Contents List

Hunter GA Mk.11 and PR Mk.11 Aircraft – Alighting Gear – Brake Units AH 50247 and AH 50248 – Introduction of locking plate assy. AH 083817 in lieu of AH 082987 (27G/6900)

Hunter GA Mk.II and PR Mk.II - Main Undercarriage - Mk. 2
Maxaret installations AH.50720 and AH.50721. To provide for
Removal and Replacement of Maxaret Units (Dunlop Mod. No.3160)

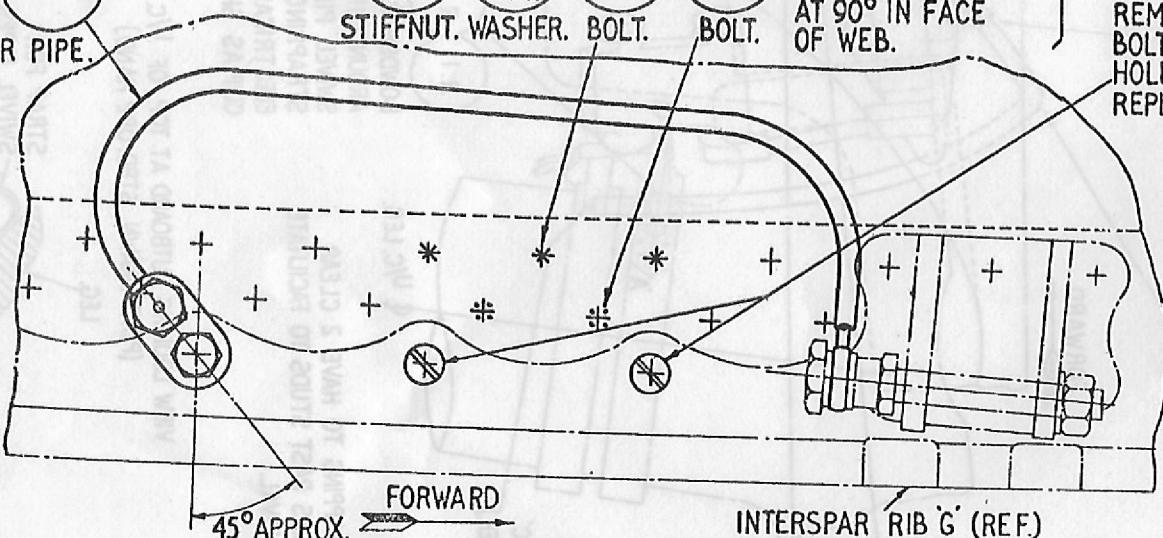
REMOVE 5 EXISTING BOLTS IN WAY OF
U/C LEG, & REPLACE WITH:-

OPEN OUT 5 HOLES
 $7/32$ " DIA. HAWKER
FIT C, C'SK.07" DEEP
AT 90° IN FACE
OF WEB.

REMOVE 2 EXISTING
BOLTS A.25. 6.C. C'SK.
HOLES .08" DEEP AT 90°
REPLACE WITH:-

(21) Remove greaser pipes Part No A.200194 (port) and Part No A.200195 (starboard) from interspar rib 'G' modify by re-bending and re-part Number as A.206280 (port) and A.206281 (starboard) and refit, as shown on Sheet 1 of the drawing.

(22) Modify interspar rib 'G' (port and starboard) and fit new bolts, Part No F.179820 and F.187605 and replace bolts, Part No A.25.6.C with bolts, Part No AS.1242/6/C as shown on Sheet 1 of the drawing.

DRAWING N°.
AP.101B-1309-2/B5/76
Sheet 2

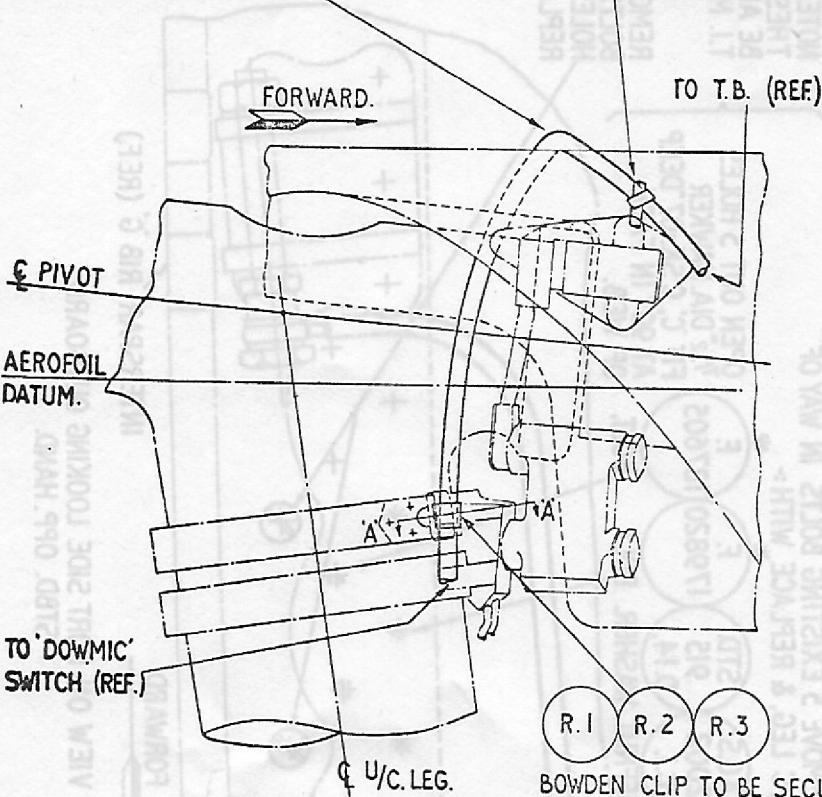
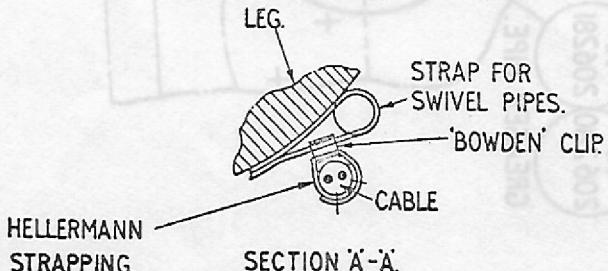
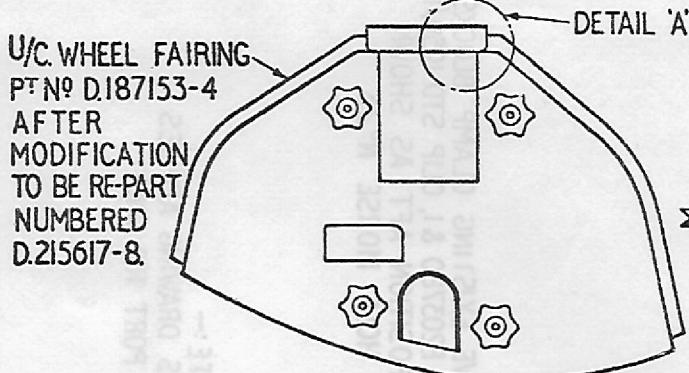
ELECTRIC CABLES TO BE RUN AS SHOWN. CARE TO BE TAKEN TO ENSURE THAT CABLES ARE NOT STRAINED WHEN LEG IS RETRACTED.

ELECTRICAL CABLE TO BE STRAPPED TO HYDRAULIC PIPE.

NOTE- STRAPPING TO HAVE 2 CLEAR HOLES PAST STUDS TO FACILITATE REMOVAL.

BOWDEN CLIP TO BE SECURED AROUND UPPER STRAP FOR SWIVEL PIPES. HELLERMANN STRAPPING TO FASTEN ELECTRICAL CABLE TO BOWDEN CLIP AS SHOWN. SEE SECTION A-A

(24) Re-run the U/C leg compression switch electrical cable and secure to upper strap for swivel pipes and hydraulic pipe, ensuring that there is sufficient slack left in the cable to avoid straining when the leg is retracted as shown on Sheet 2 of the drawing.

VIEW LOOKING OUTBOARD ON
MAIN U/C WHEEL FAIRING.
(PORT AS DRAWN. STBD. OPP. HAND.)

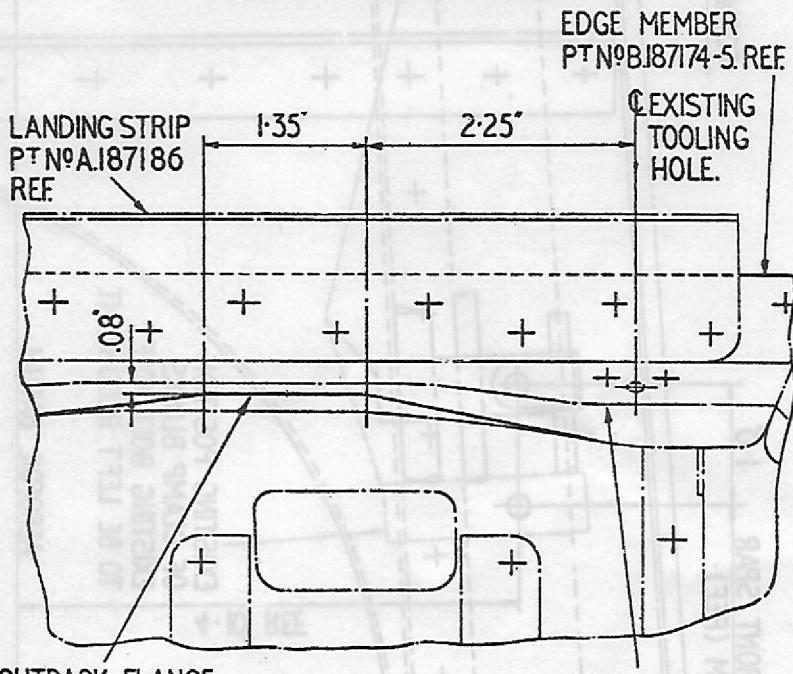
DETAIL 'A'
VIEW LOOKING OUTBOARD ON
OUTBOARD EDGE MEMBER.
(PORT AS DRAWN. STBD. OPP. HAND.)

CUTBACK FLANGE
OF EDGE MEMBER
AS SHOWN &
THEN BLEND IN
CUT-OUT TO HIGH
POINTS OF THE
FLANGE.

(27) Modify the port and starboard main undercarriage wheel fairings by cutting back flange of edge member Part No B.187174 (port) and Part No B.187175 (starboard); suitably obliterate the transfer "leg pressure 1500 psi etc" on the inside of the fairings and re-Part Number as D.215617 (port) and D.215618 (starboard) as shown on Sheet 3 of the drawing.

AP.101B-1309-2/B5/76
Sheet 4

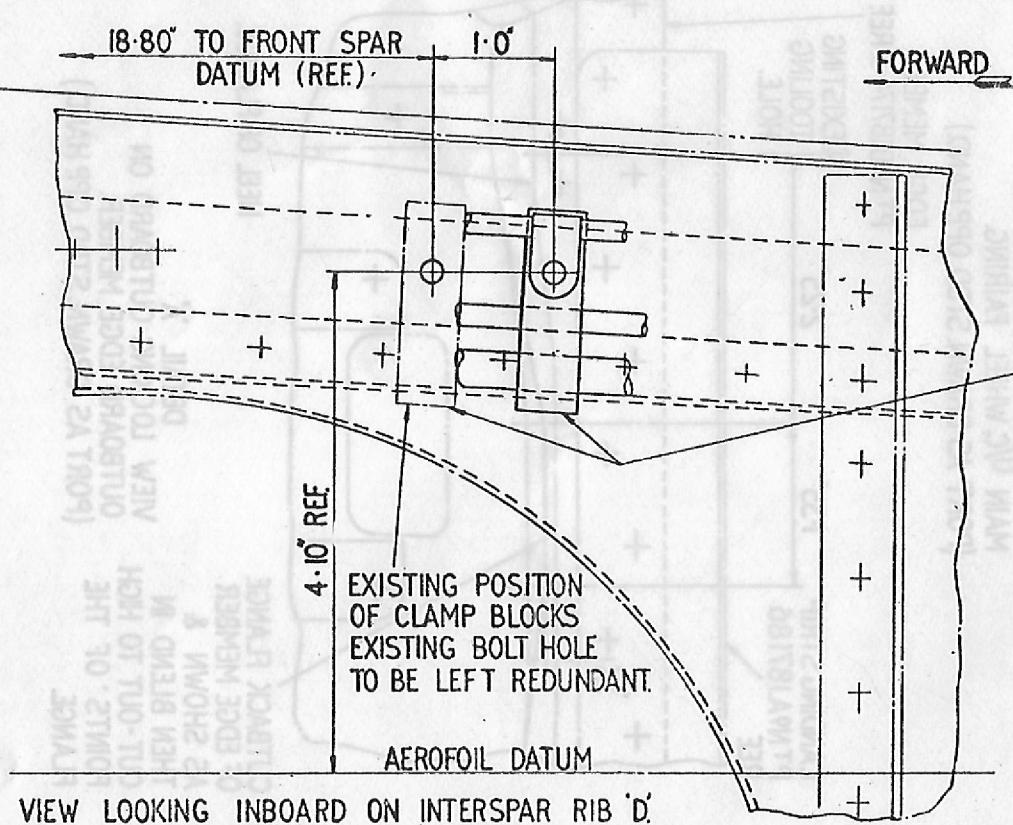
REMOVE EXISTING CLAMP BLOCKS
PT. N° F203780 & I, CLIP STD. 1959/1
& REPOSITION AFT AS SHOWN.
DRILL HOLE MORSE N° 25.

NOTE:-
THIS DRAWING APPLIES
TO PORT RIB ONLY.

(16) Modify interspar rib 'D' and reposition existing clamp block, Part No F.203780 and F.203781 and clip, Part No Std.1959/1 - port side only - as shown on Sheet 4 of the drawing.

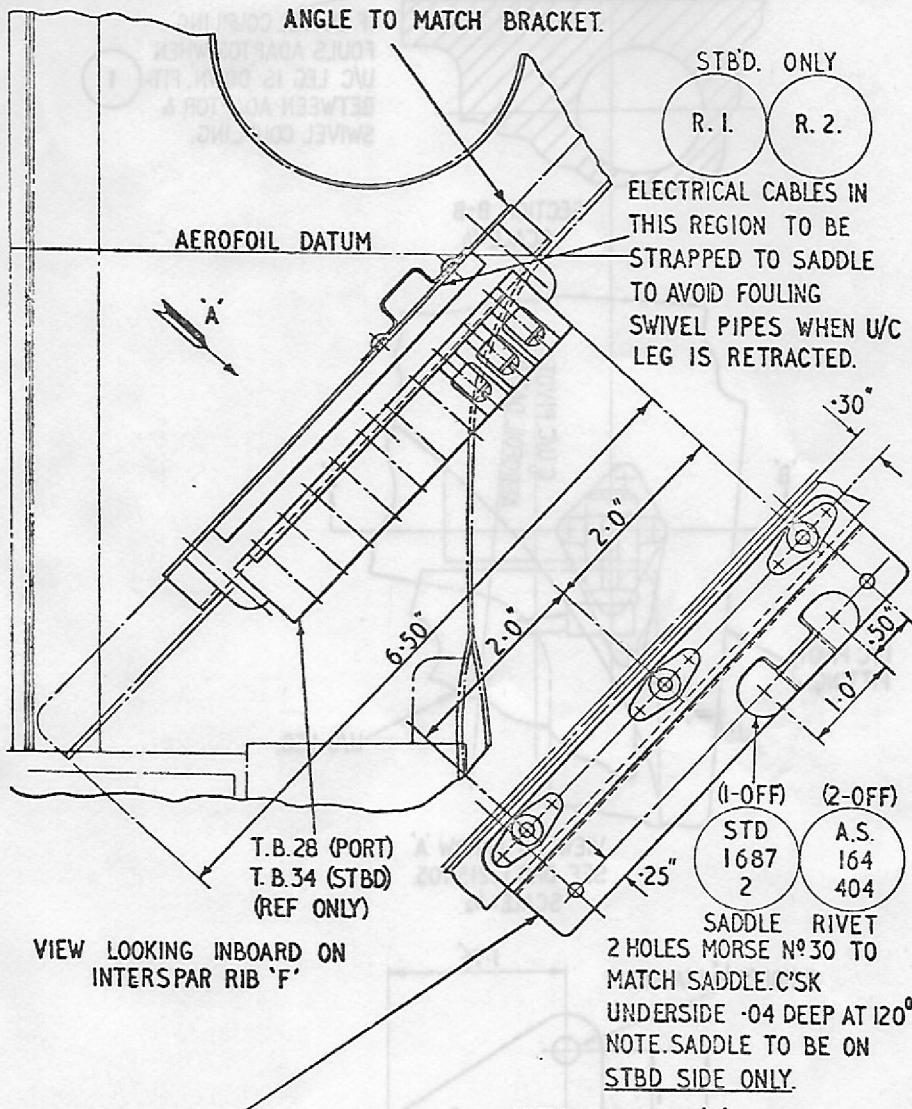
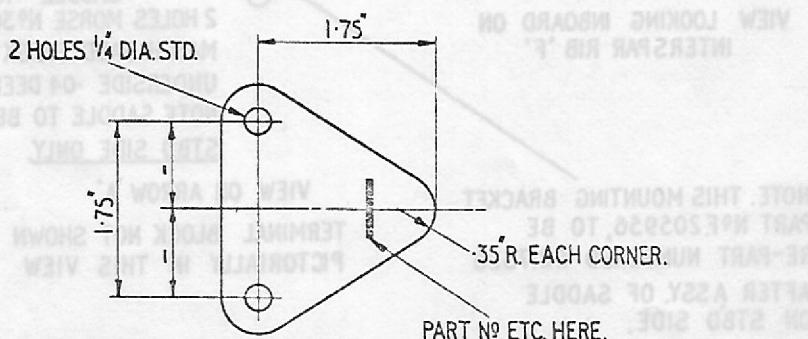
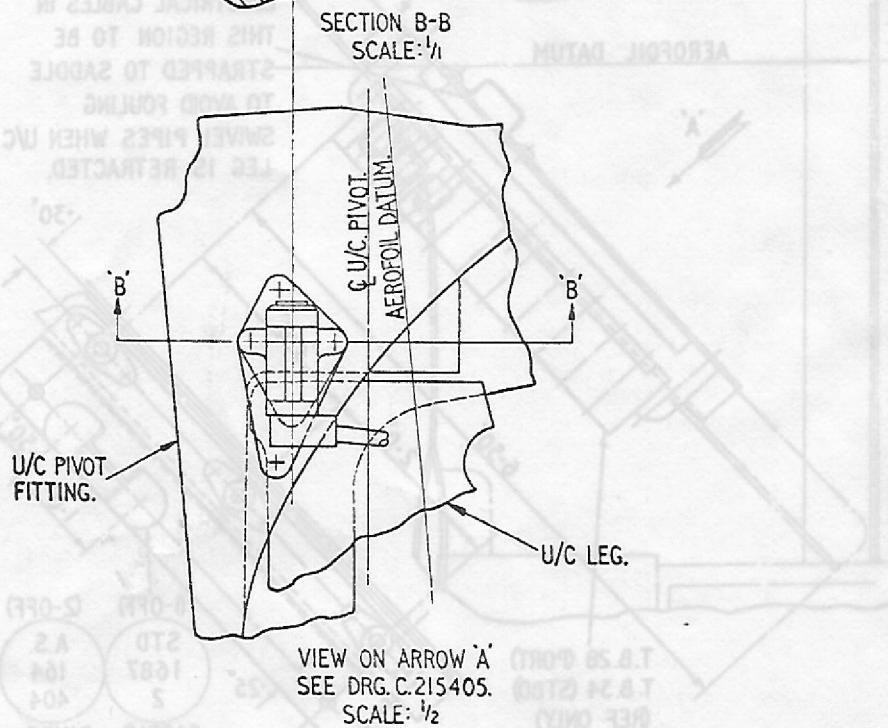
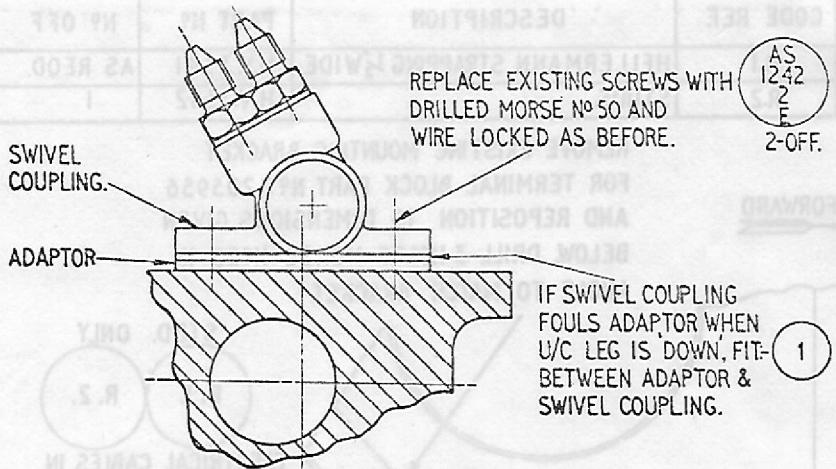
REMOVE EXISTING MOUNTING BRACKET
FOR TERMINAL BLOCK PART NO F.205956
AND REPOSITION TO DIMENSIONS GIVEN
BELOW. DRILL 3 HOLES MORSE NO25 IN
ANGLE TO MATCH BRACKET.

NOTE. THIS MOUNTING BRACKET
PART NO F.205956, TO BE
RE-PART NUMBERED F.217326
AFTER ASSY. OF SADDLE
ON STBD SIDE.

(19) Modify interspar F (starboard) by removing bracket, Part No F.205956, fitting saddle, Part No Std.1687/2 re-part numbering bracket as F.217326 and refitting bracket as shown on Sheet 5 of the drawing.
